VSP-37
July 7, 1982

VENDOR SERVICE PUBLICATION

To: All Piper Distributors and CORPAC's
Subject: Bendix Service Bulletins 615, 620, 621

Figure 1

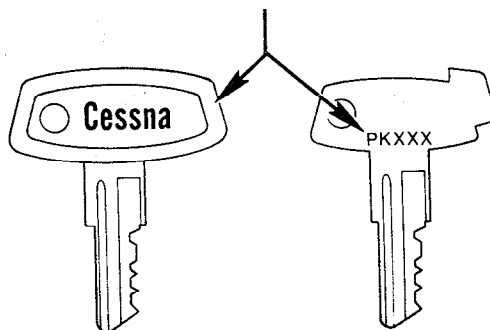
NOTE: The key PK number is located on the key as indicated in figure 1.

Key PK number
stamped in this area.

Have to remove black rubber
from top of key to expose
the PK number.

Figure 1. 10-157197 Distributor Gears with Different Timing Marks

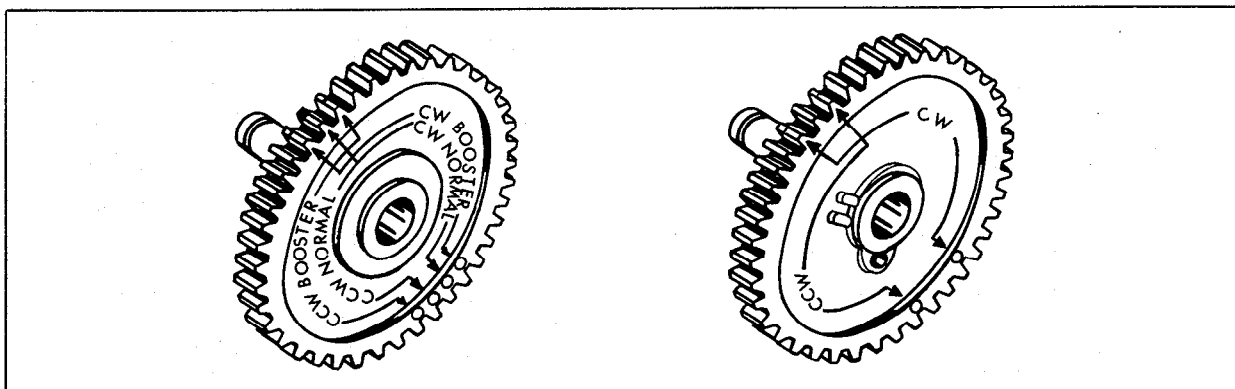
2. If old distributor gear, P/N 10-157197, which incorporated two different molded timing identification marks was used (see figure 1), proceed as follows:

- a. Remove paint from booster timing positions with suitable solvent.
- b. Locate normal timing tooth between CW and CCW booster chamfered teeth and paint this tooth and the applicable inner timing mark with red Dykem or red lacquer in accordance with figure 2 or figure 4 for appropriate gear.

Figure 3. Timing Marks on Present Production Distributor Gear Kit Assembly 10-357586

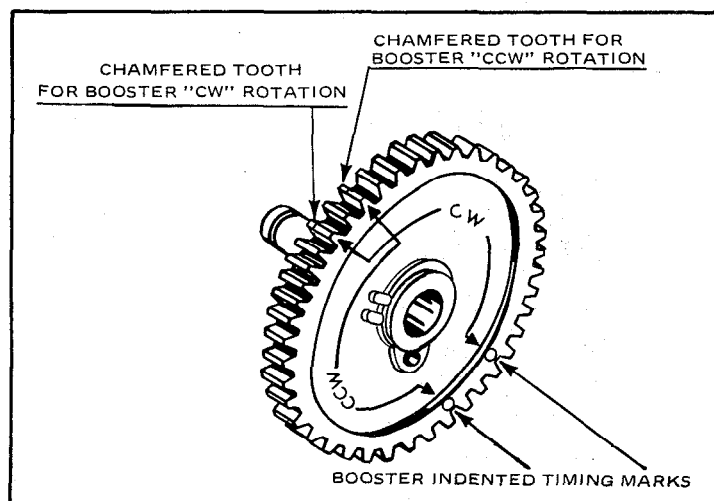
3. If present production distributor gear as supplied in kit P/N 10-357586 is used (see figure 3) proceed as follows:

The molded timing marks incorporated in new present production nylon spare part gears, as supplied in kit, P/N 10-357586, are for the booster timing position. Before installation of a new gear kit, the applicable normal timing mark and center tooth must be marked with red

- Remove paint from booster timing positions with suitable solvent.
- Locate normal timing tooth between CW and CCW booster chamfered teeth and paint this tooth and the applicable inner timing mark with red Dykem or red lacquer in accordance with figure 4.

Figure 4. Present Production Distributor Gear Assembly with Additional Timing Marks Painted

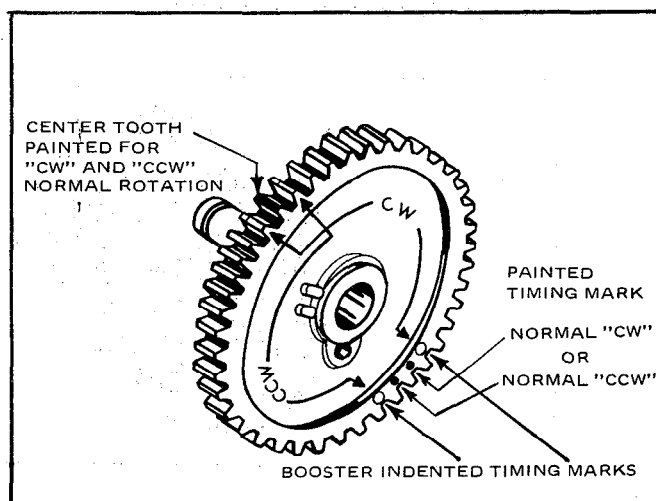
Dykem or red lacquer as illustrated in figure 4.

- Reassemble the magneto using the applicable **normal** timing mark on distributor gear.
- After magneto has been reassembled, identify the magneto by stamping the letter "R" in the upper left hand corner of the identification plate using a $\frac{1}{16}$ inch metal stamp.
- Make an appropriate engine Log Book entry indicating that this Service Bulletin has been complied with, recording magneto serial number.

Original Gear Make Up
(Not incorporating insulating or plain steel skid washer.)
Figure 1

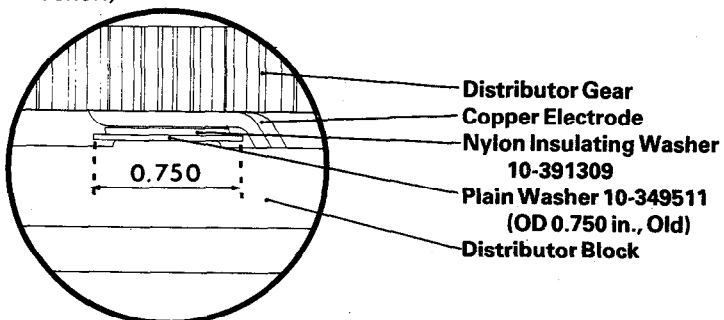
1. Remove the top timing plug.
2. Using a concentrated light beam (a pen light or equivalent) look into the timing hole at the area between the distributor gear and the distributor block parts for existing washer configuration.
3. Current configuration should be as shown in figure 3.
4. Rework magneto whenever configuration is as shown in figure 2.
5. An acceptable configuration is shown in figure 1.

Insulated Gear Configuration
(Incorporating 10-357586 Kit parts with *incorrect* washer.)
Figure 2

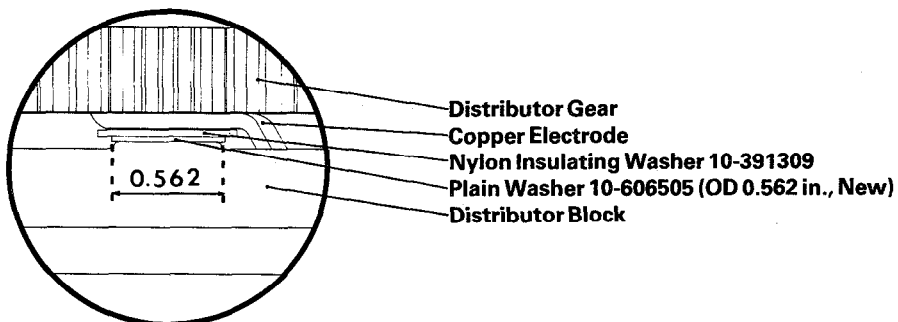
It has been determined that plain steel washer P/N 10-349511 installed on the gear axle between the nylon insulating washer P/N 10-391309 and the distributor block bronze oil-lite bushing (see figure 2) can cause electrical flash-over in the distributor at altitude. Inspect for compliance as follows:

1. Remove magneto from engine.
2. Disassemble as required using procedures described in Bendix Overhaul Manual Form No. L-205-10 for S-20 and L-527-4 for S-200 series magnetos.
3. Remove retaining ring and plain washer. Discard retaining ring. Remove distributor gear from the distributor block.
4. Inspect the distributor block for burning or carbon tracking and serviceability. Replace if defective.
5. Remove old plain steel washer P/N 10-349511 (OD 0.750 in.) and nylon insulating washer P/N 10-391309 from the gear axle.
6. Reinstall nylon insulating washer P/N 10-391309 and install new plain washer P/N 10-606505 (OD 0.562 in.) on gear axle. See figure 4 for assembly order.
7. Wipe distributor gear axle clean, then reinstall it in the block. Place plain washer P/N 10-349511

on axle shaft and secure with new retaining ring P/N 10-92815-37.
